INDIAN POINT NUCLEAR
GENERATING UNIT NO. 2
(Docket No. 50-247)

INSERVICE INSPECTION AND
TESTING PROGRAM

Supplement No. 3

Supplement No. 3

Figure E5-1 - SAFETY INJECTION PUMP ACCEPTANCE CRITERIA A

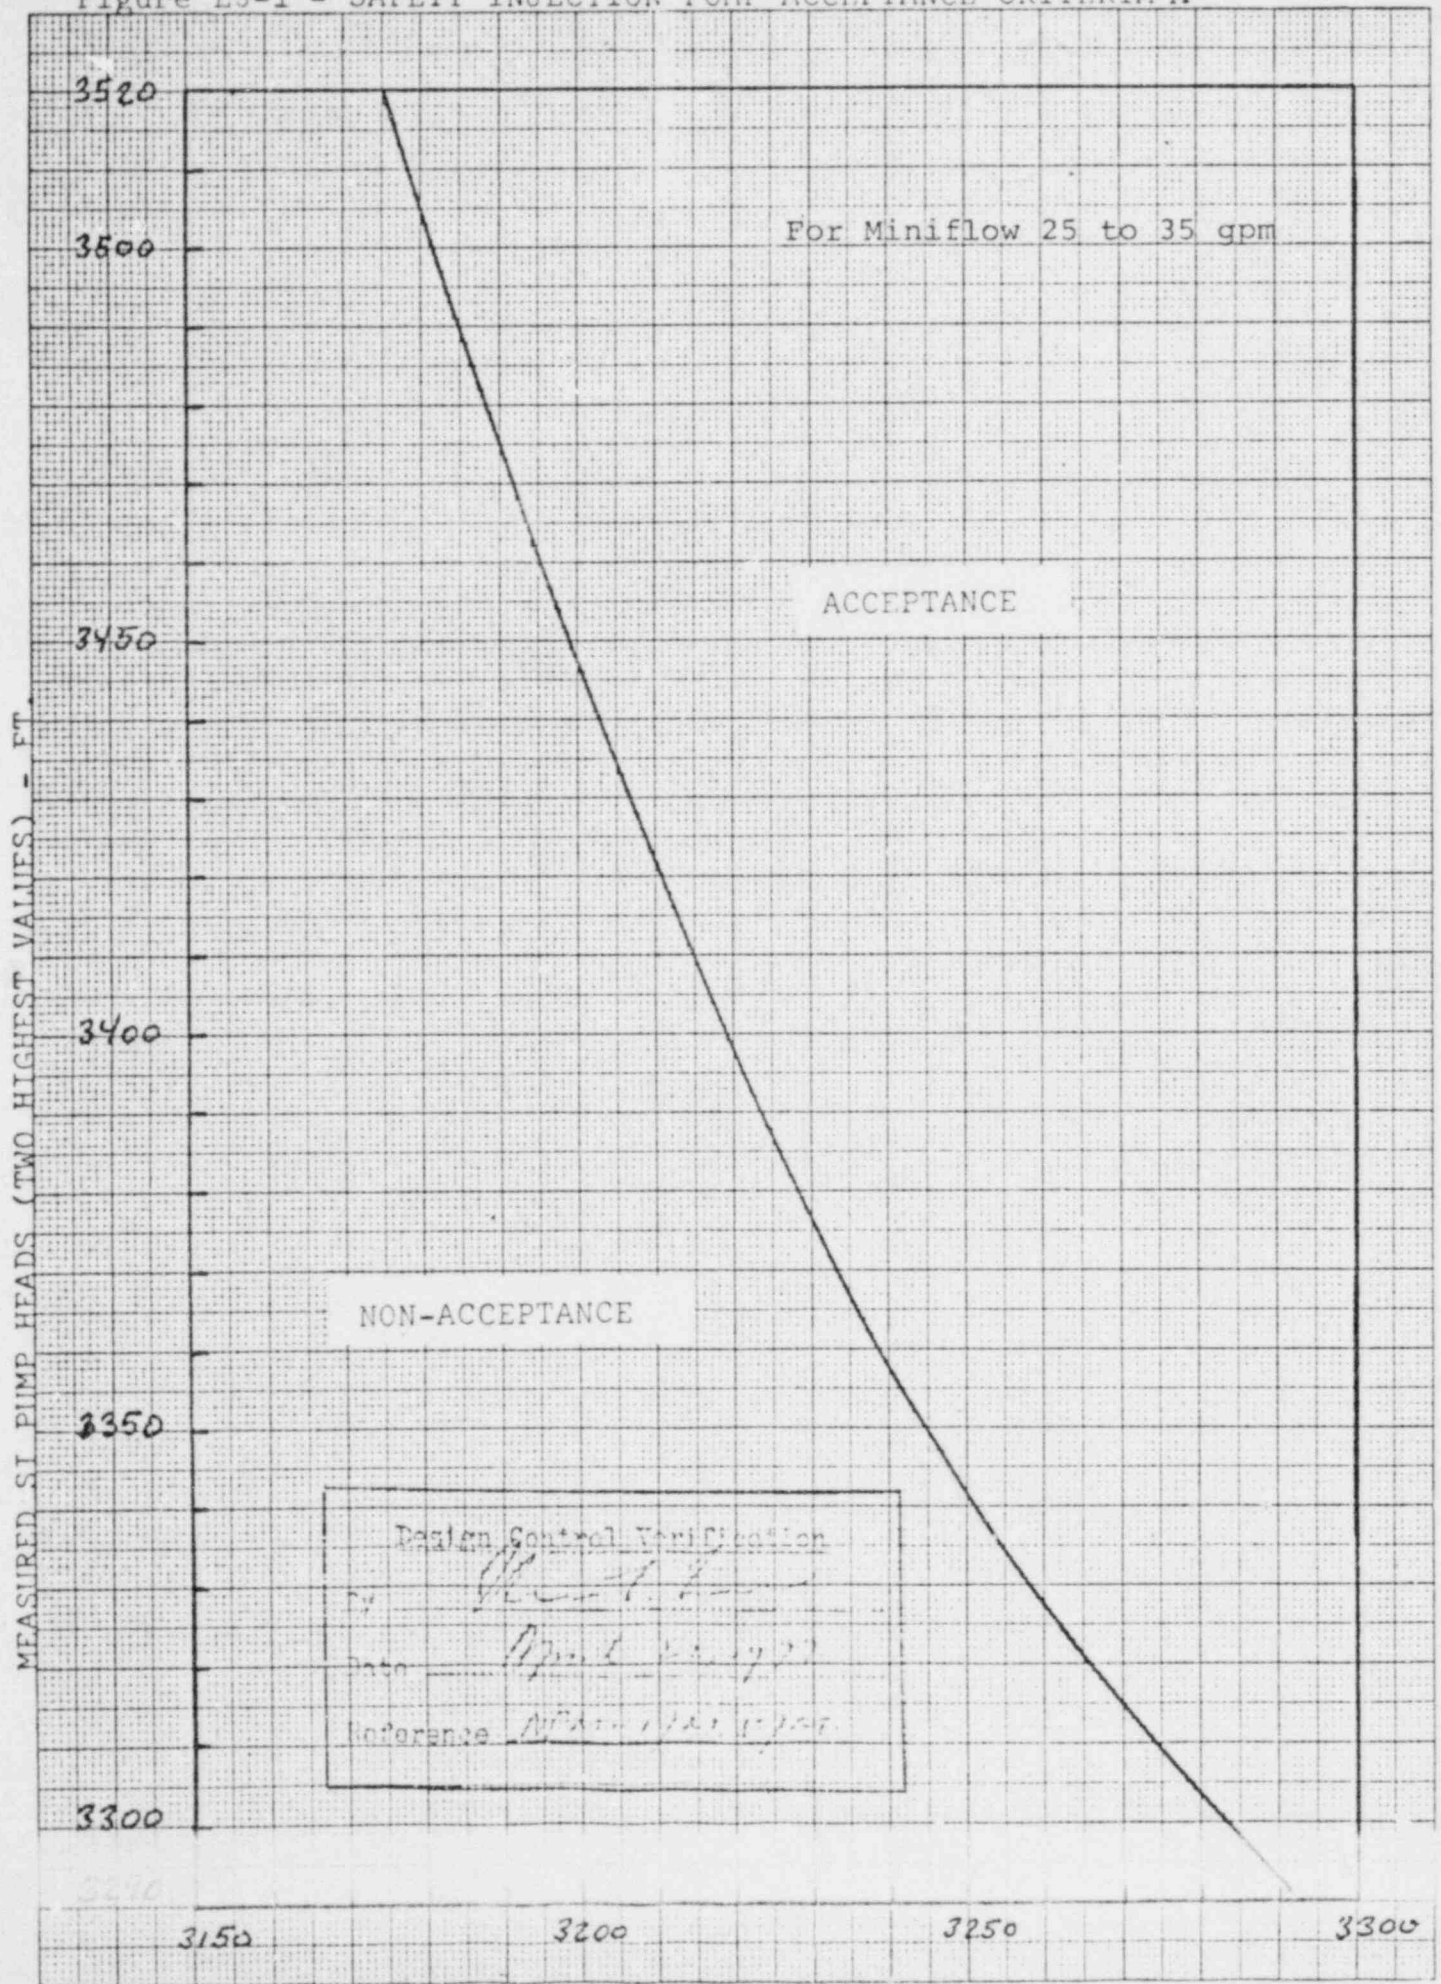
- (a) the safety injection pumps shall be considered operable if the pump heads are greater than 3,292 feet or,
- (b) if one pump head is below 3,292 feet, the safety injection pumps shall be considered operable if the heads for the two higher head pumps are in the acceptance region of attached Figure E5-1.

Figure E5-2 - SAFETY INJECTION PUMP ACCEPTANCE CRITERIA B

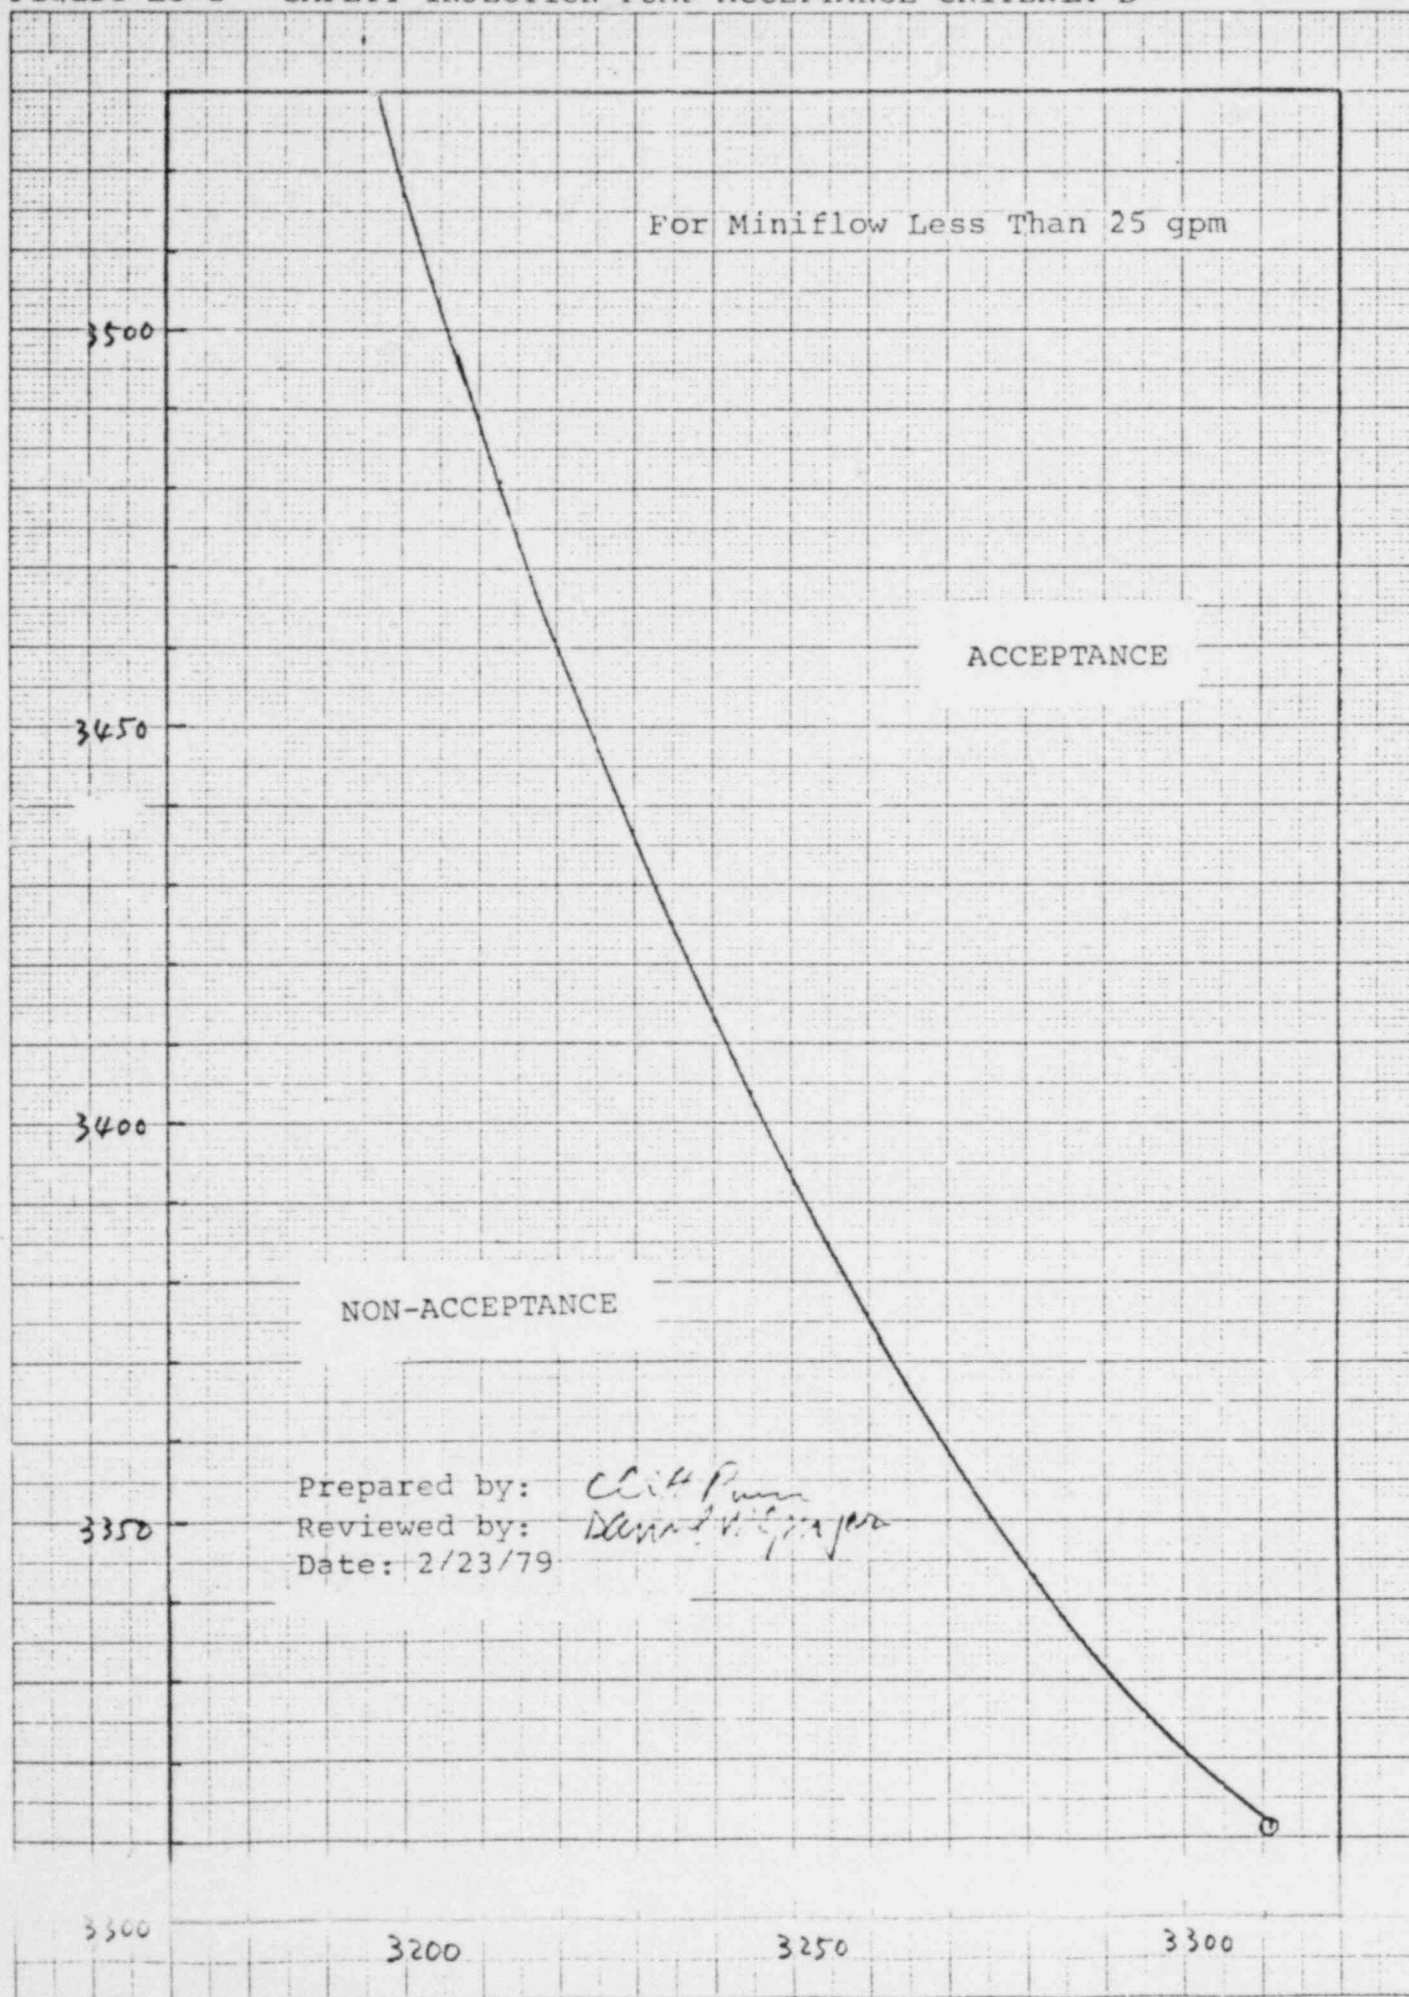
- (a) the safety injection pumps shall be considered operable if the pump heads are greater than 3,311 feet, or
- (b) if one pump head is below 3,311 feet, the safety injection pumps shall be considered operable if the heads for the two higher head pumps are in the acceptance region of attached Figure E5-2.
